ADDENDUM TO THE CONTRACT DOCUMENTS	Page Number 1	No. of Pages 3
<u>Addendum No.</u>  4	<u>Date Addendum Issued</u>  April 9, 1999	
<u>Issuing Office</u>  Anton K. Johansen, P.E. Regional Director, Northern Region Department of Transportation and Public Facilities 2301 Peger Road Fairbanks, AK 99709-5399	<u>Previous Addenda Issued</u>  No. 1 issued March 12, 1999 NTB #1 issued March 18, 1999 No. 2 issued March 26, 1999 NTB #2 issued April 1, 1999 No. 3 issued April 2, 1999	
<u>Project:</u> Unalakleet Landfill Road  <u>Project No.:</u> STP-0002(47)/66482	<u>Date and Hour of Bid Opening</u>  April 13, 1999 at 2:00 p.m. Prevailing Time

KOUWEOOK SLOUGH BRIDGE  
UNLABLET  
SHEAR KEYS  
STATE OF ALASKA  
DEPARTMENT OF TRANSPORTATION  
AND PUBLIC FACILITIES  
ANCHORAGE, ALASKA

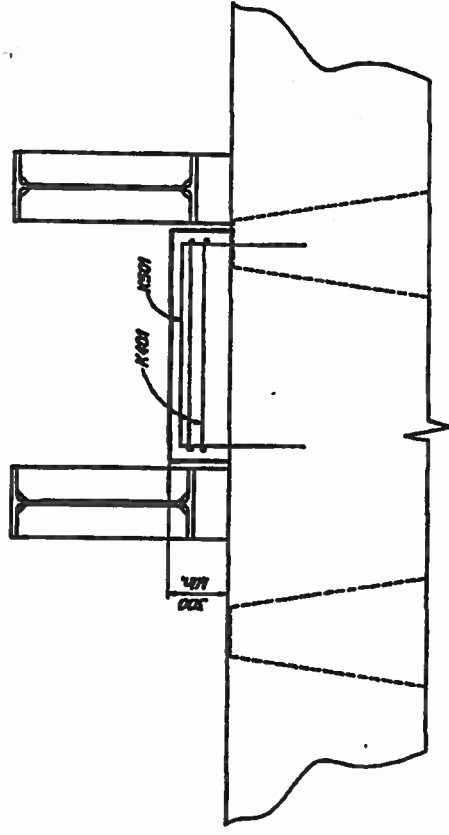
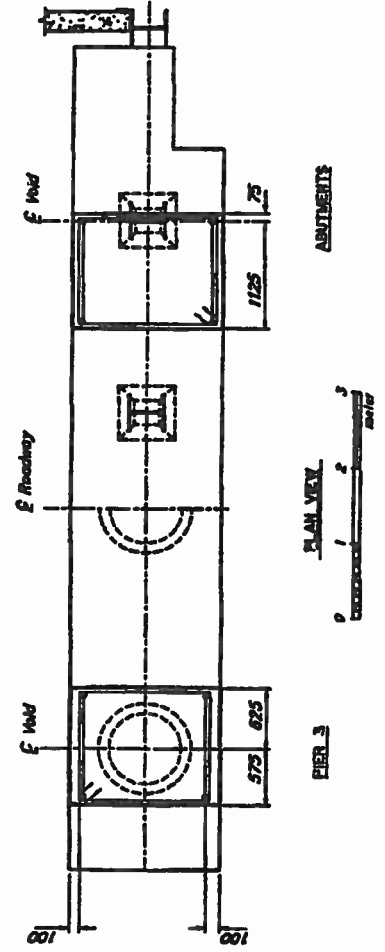
**SHEET 23.** Delete the Detail at the upper left titled "PARTIAL SECTION AT ABUTMENT AND PIERS".

Add Plan Sheet 23A identified as Attachment No. 1 to this addendum.
